Subject: P.H.O. APPLICATION NO. PHO-1-26--Z-29-23-7(8) – Notice of Pending Actions by the Planning Hearing Officer

APPLICATION NO: PHO-1-26--Z-29-23-7(8)

Request For: Stipulation Modification

Property Location: Approximately 300 feet east of the northeast corner of 43rd Avenue and Baseline Road

west elevation

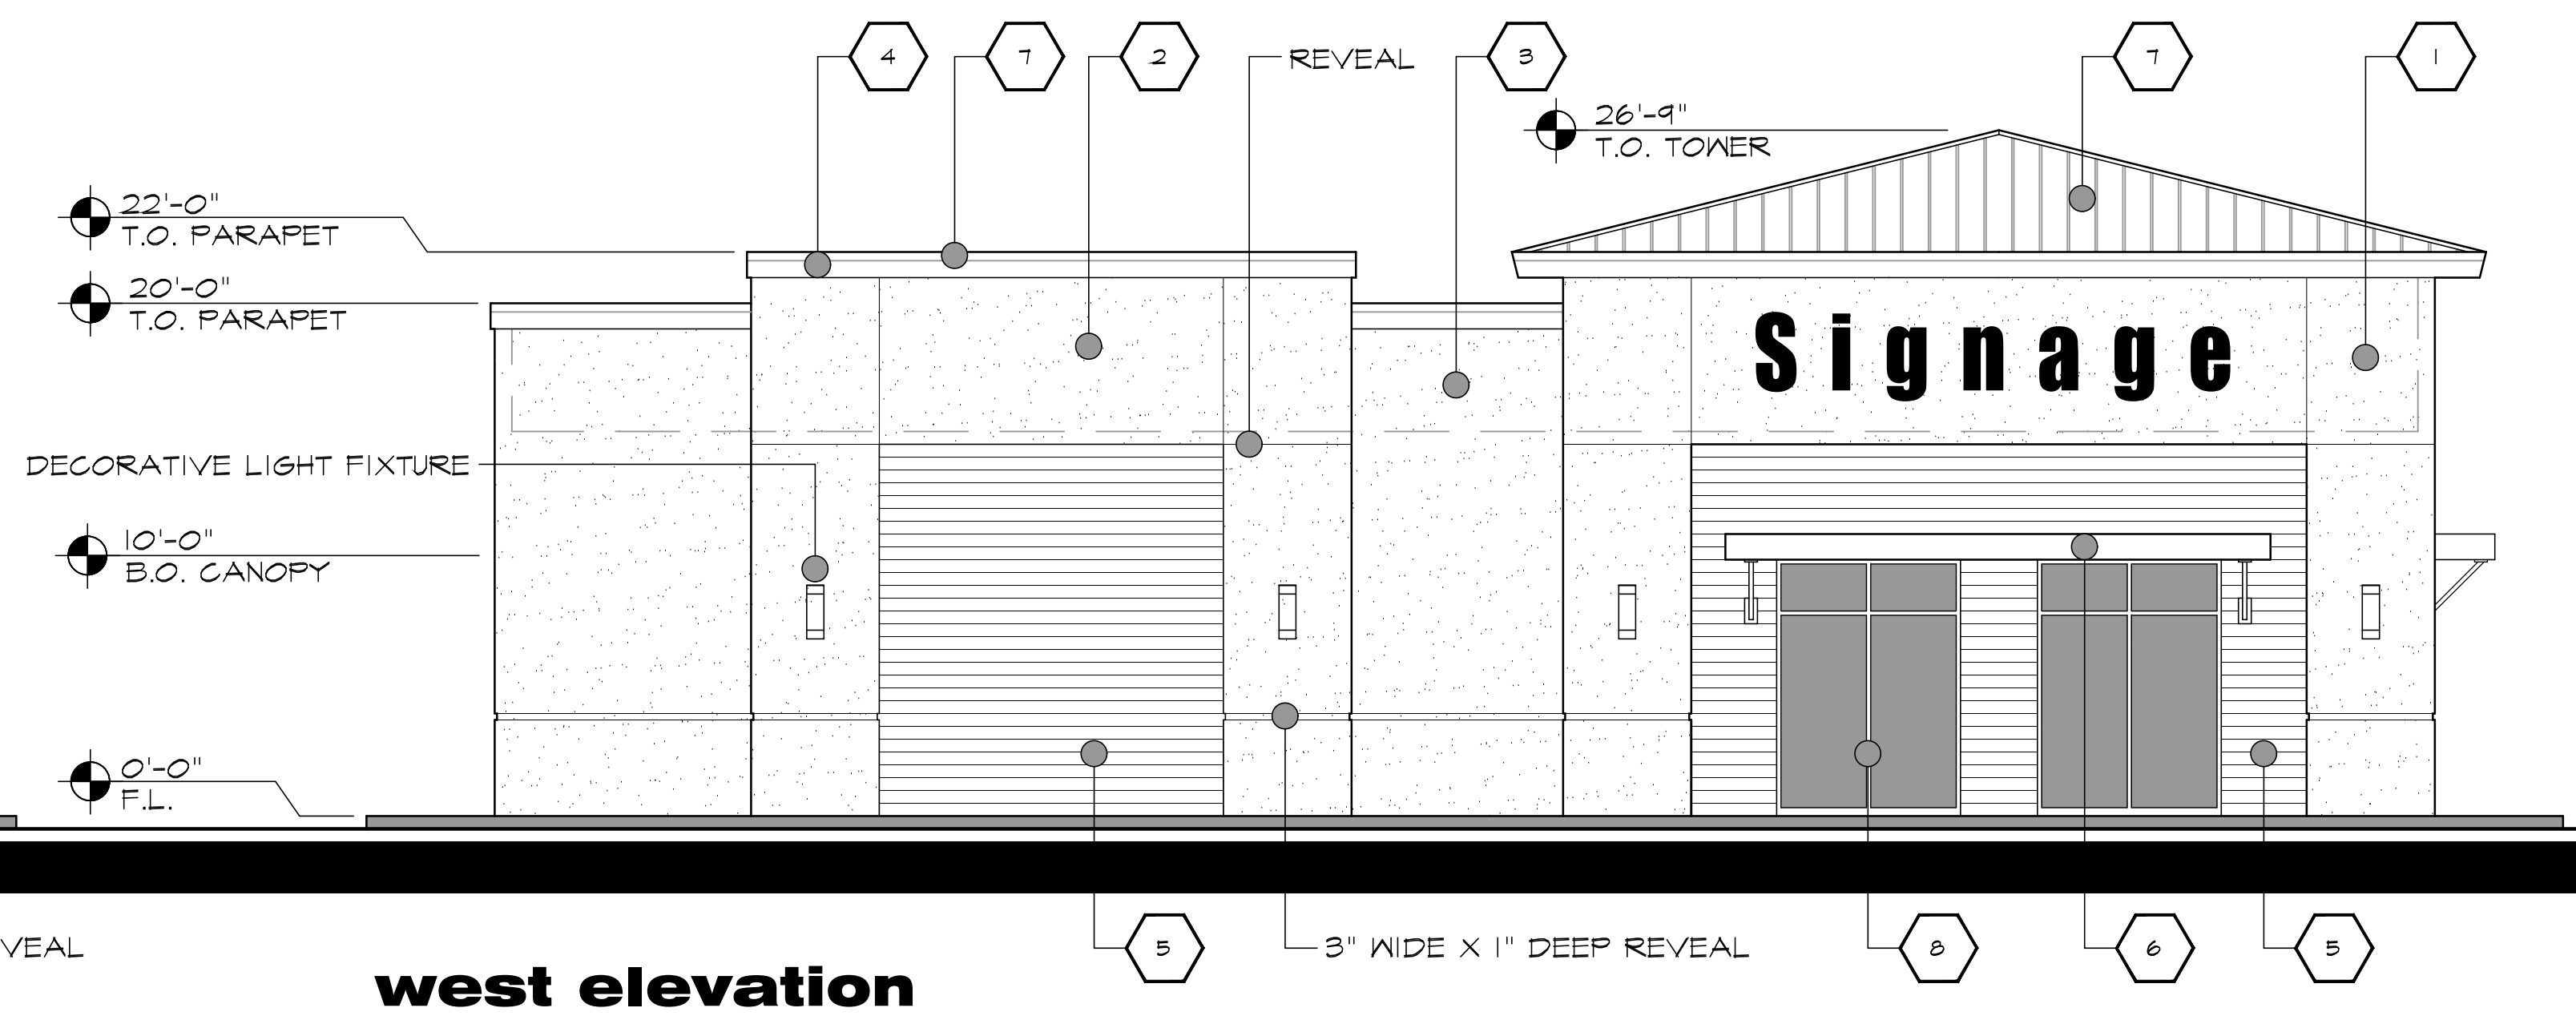
[Lot 4 Site Plan and Elevations](#)

The site plan for Lot 4 is proposed to contain a 5,625 square foot structure and ancillary surface parking. The structure is oriented towards Baseline Road to create an inviting street presence. To reduce visibility from Baseline road, the trash enclosure and loading area serving the future commercial business are located at the rear of the structure. Two bicycle racks capable of holding 4 bicycles are provided along the front of the structure. Pedestrian connectivity from Lot 4 is provided via ADA accessible paths and includes connections to the multi-use trail along Baseline Road.
